**MAINE TURNPIKE AUTHORITY**

**ADDENDUM NO. 2**

**CONTRACT 2021.05**

**YORK TOLL PLAZA DEMOLITION**  
**MILE 7.3**

SHEET NUMBER: GN-02

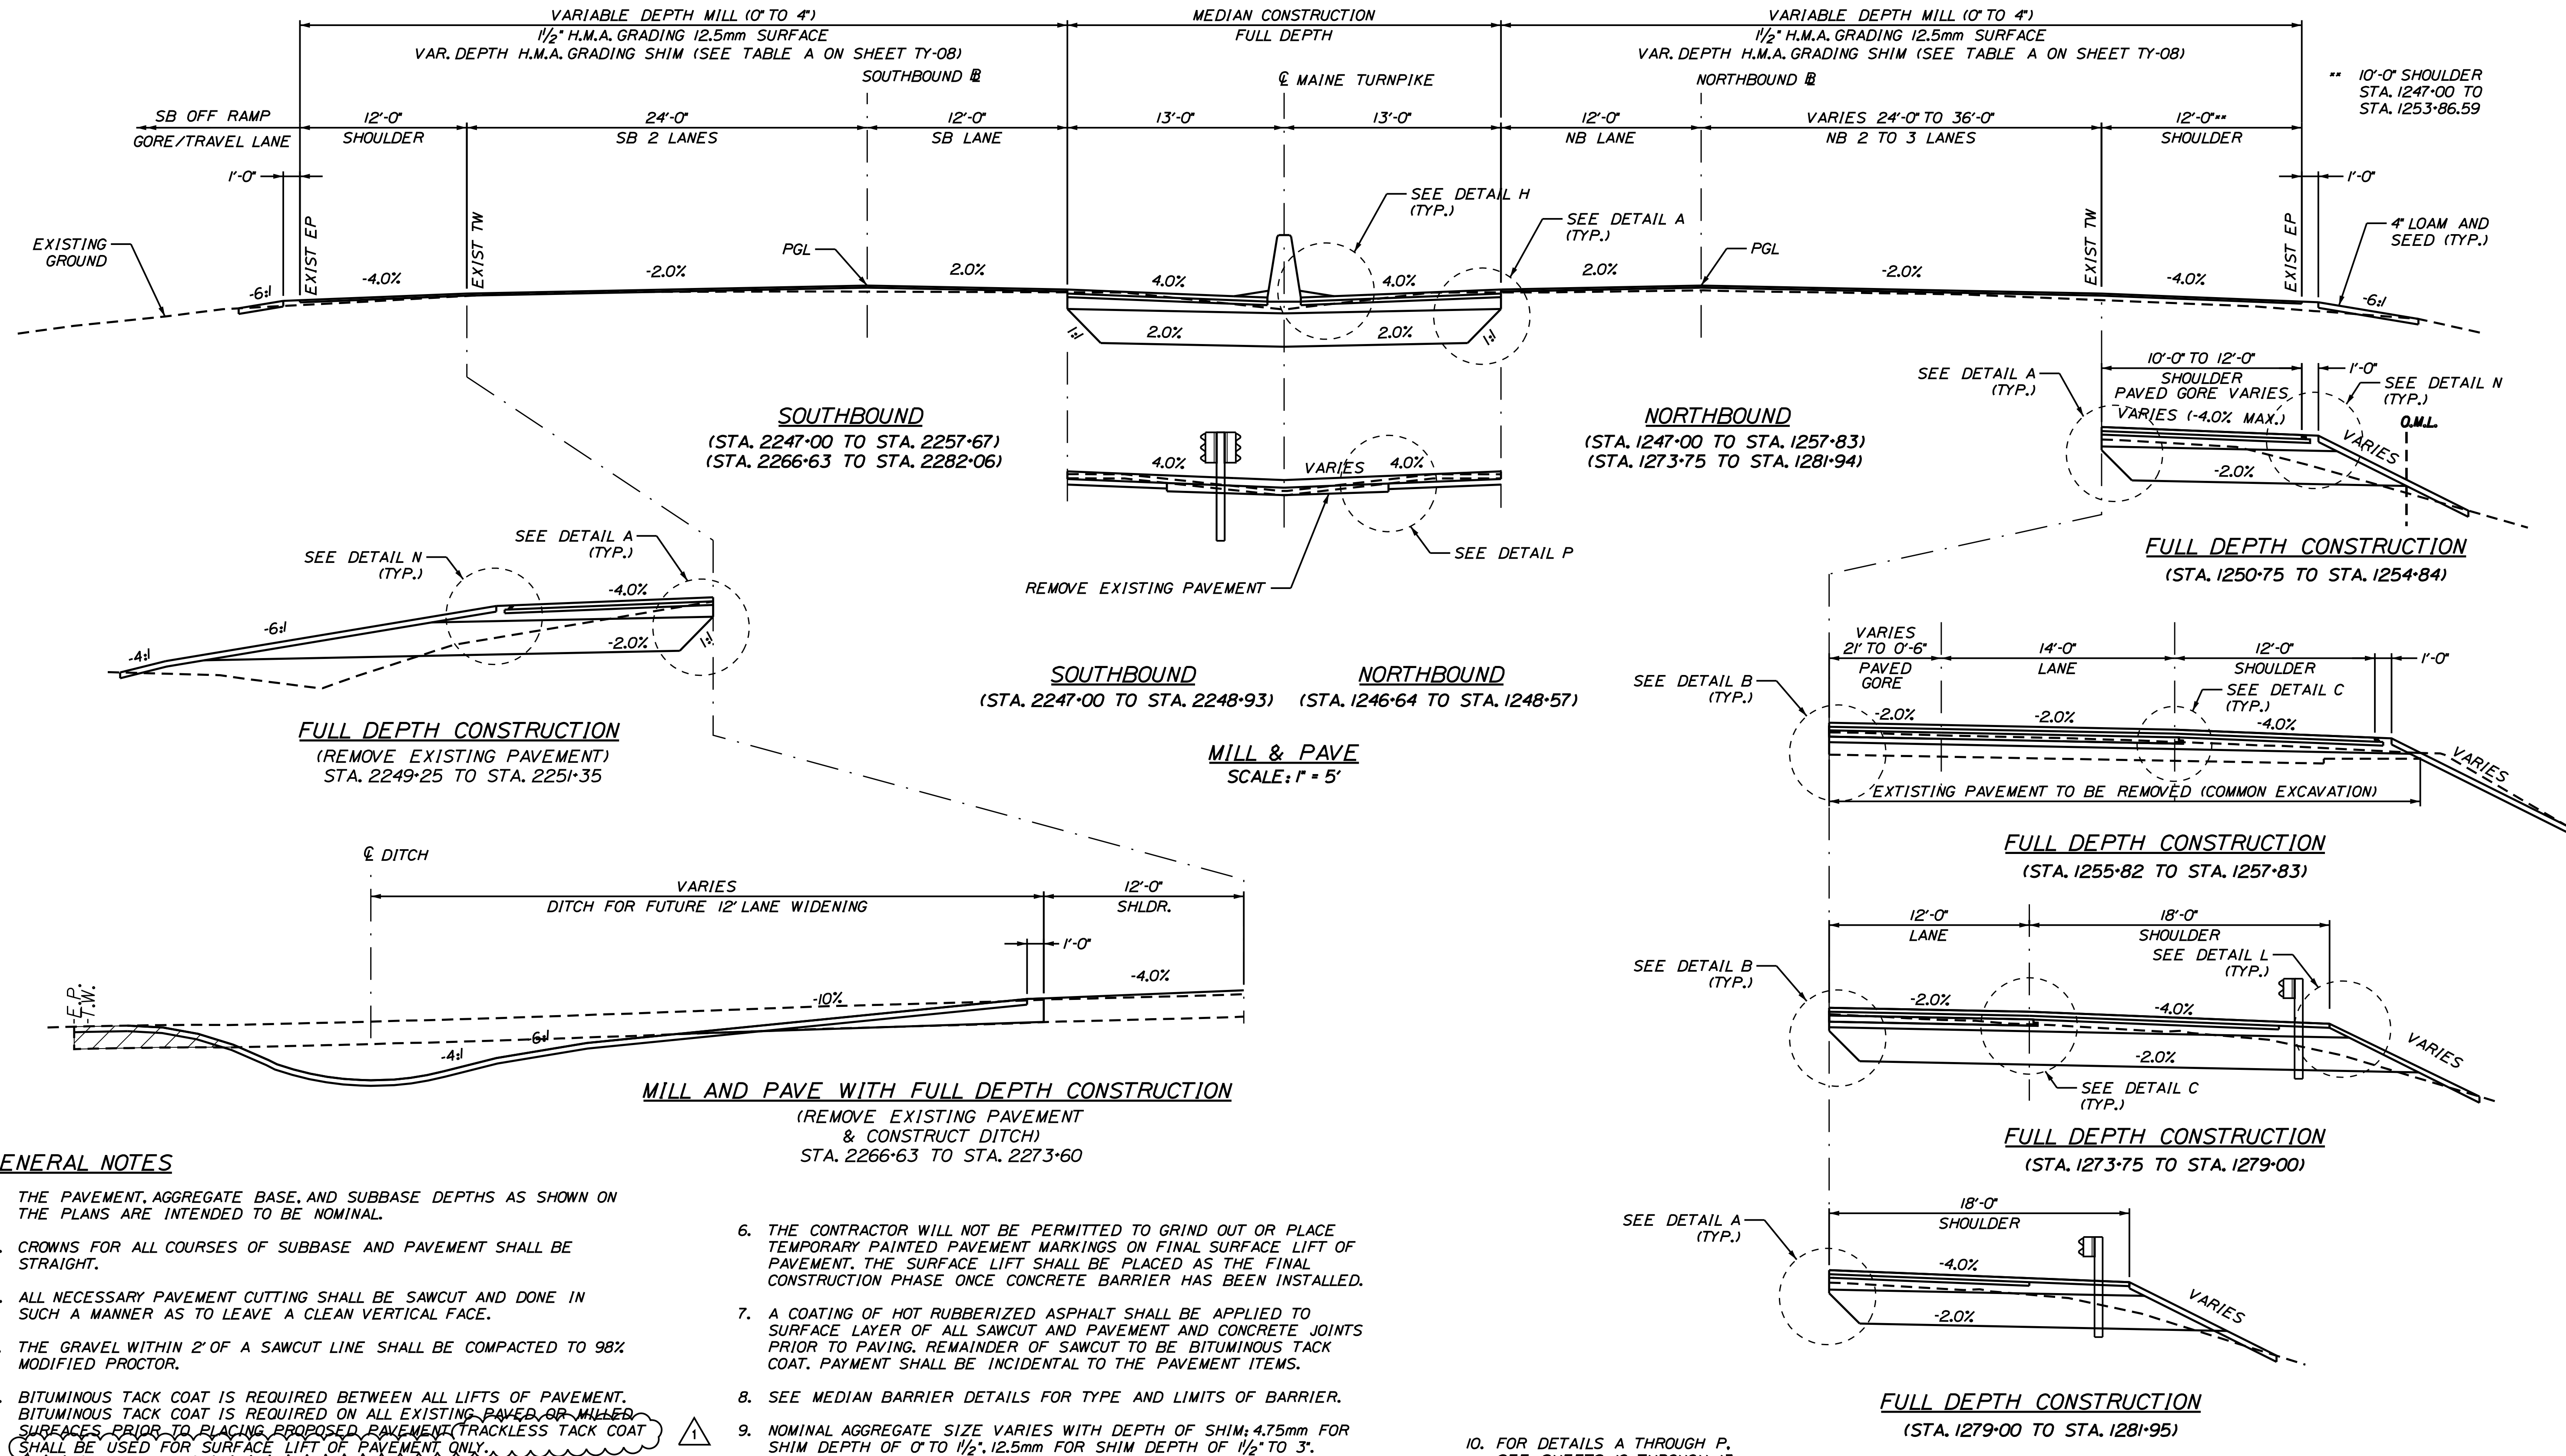
5. The earthwork calculations on sheet GN-02 call out total fill of 897 cy which was rounded up to 900 cy. The schedule of items calls for 5,997 cy of common borrow – Item 203.24. If there is only 900 cy of fill where is the 5,997 cy of common borrow to be used?

**Answer: The schedule of items is correct, sheet GN-02 is revised to match. Other changes within this addendum have changed earthwork quantities, see revised P-2 through P-12 and sheet 3 of 149.**

PAVEMENT MILL TRANSITION DETAIL  
NOT TO SCALE

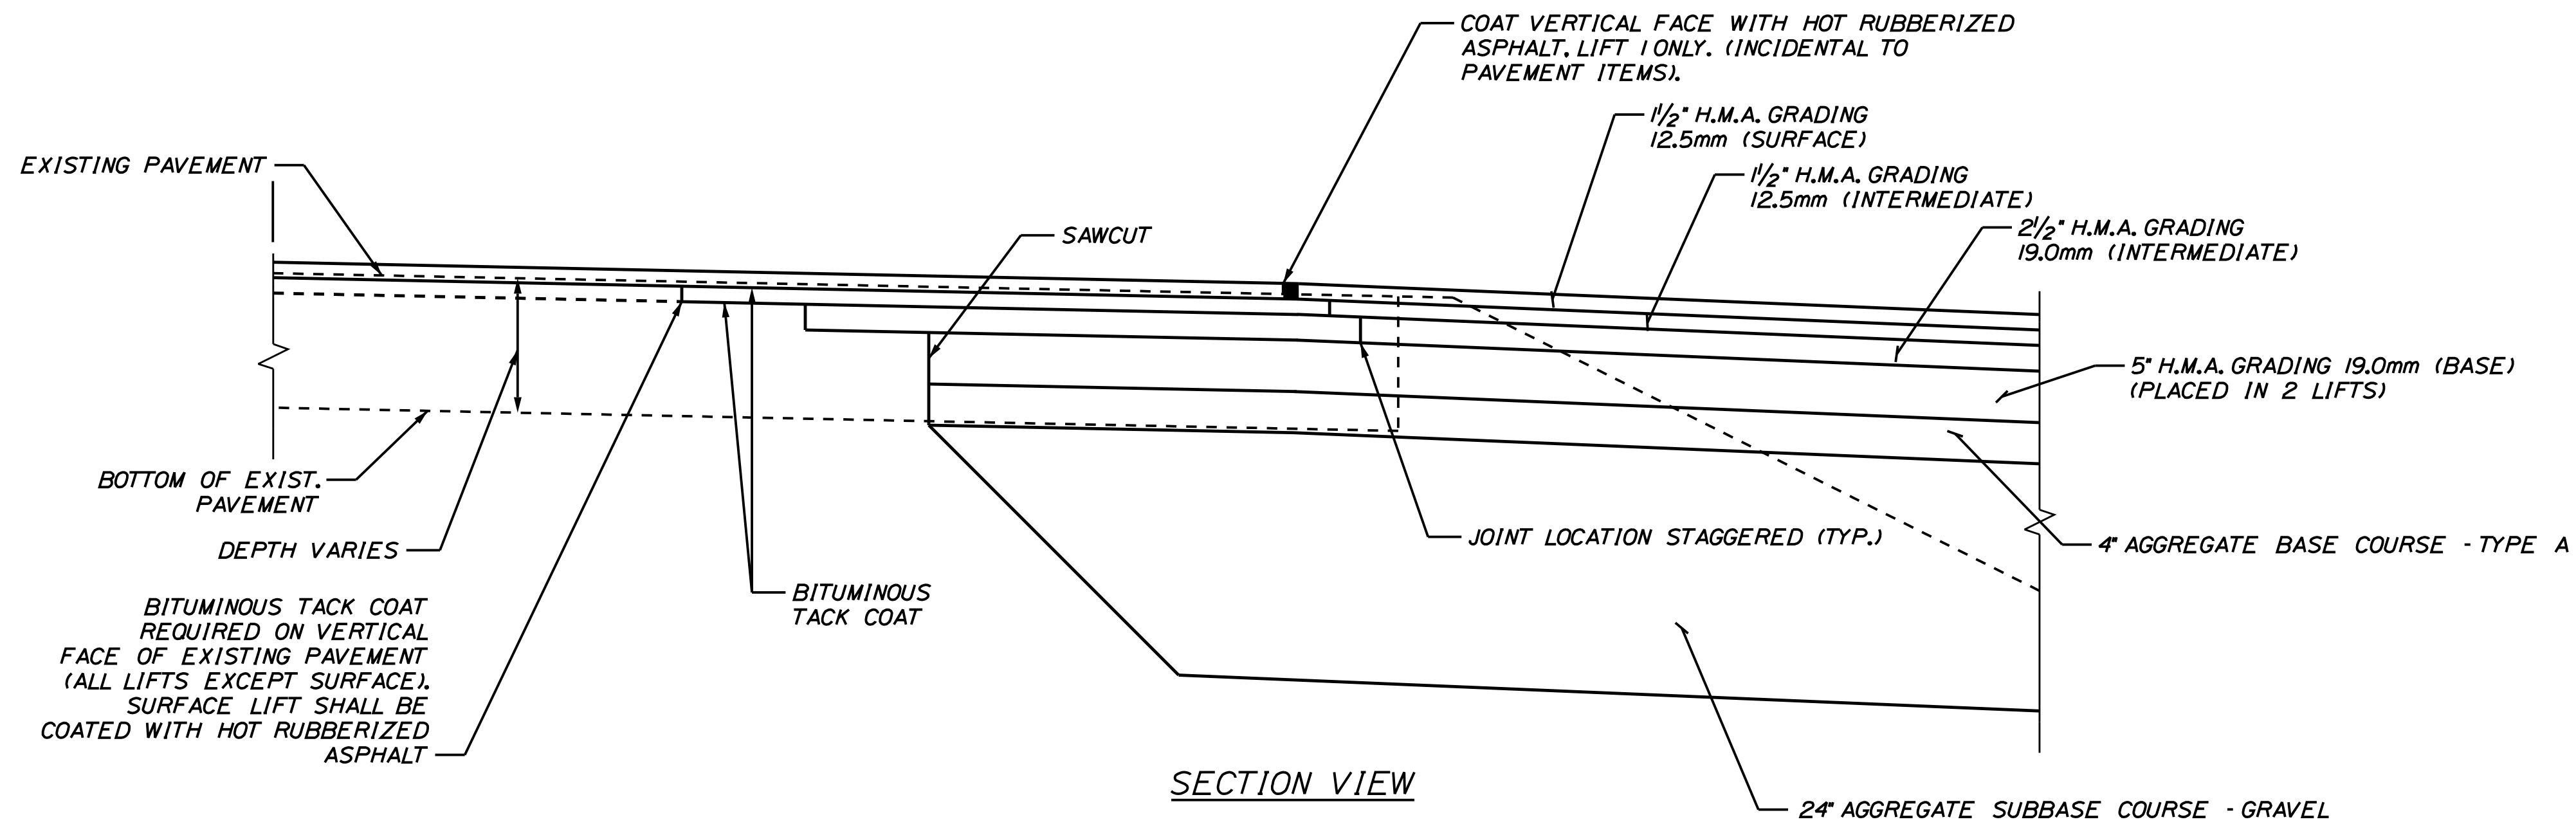
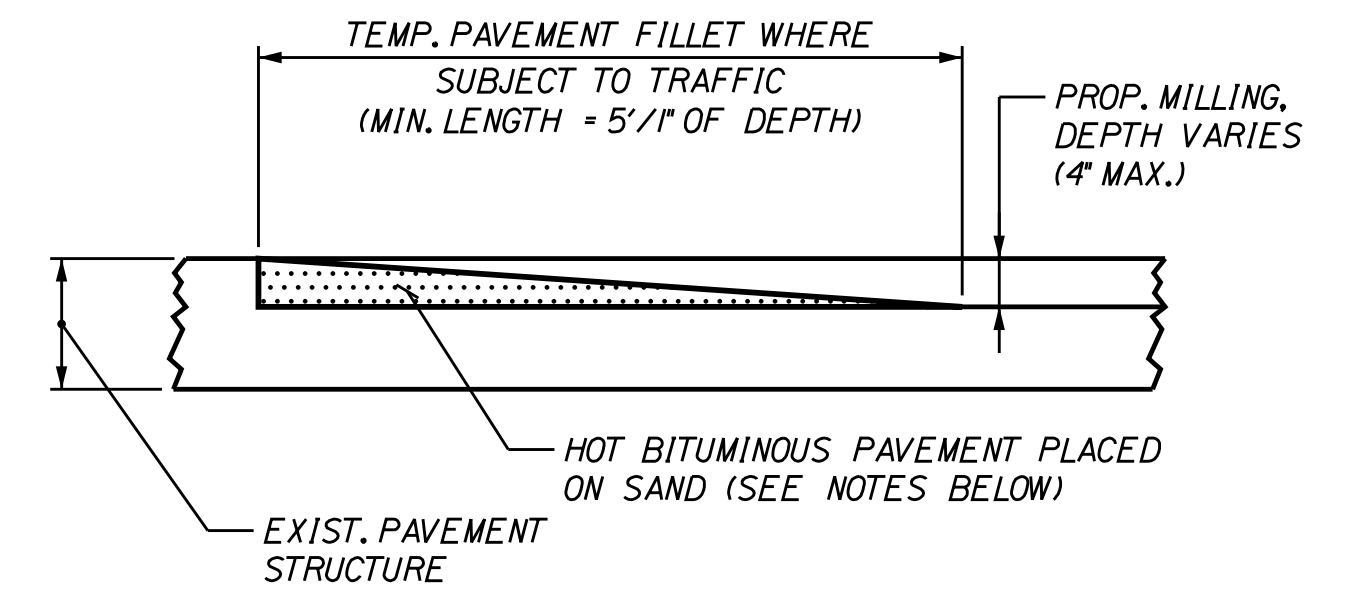
15. Are the quantities correct for Item 403.207?  
**Answer: Item 403.207 is placed in all full depth areas in addition to shim areas where a full lift can be placed below wearing and intermediate course. See Pavement Mill Transition Detail on sheet 14 of 149.**
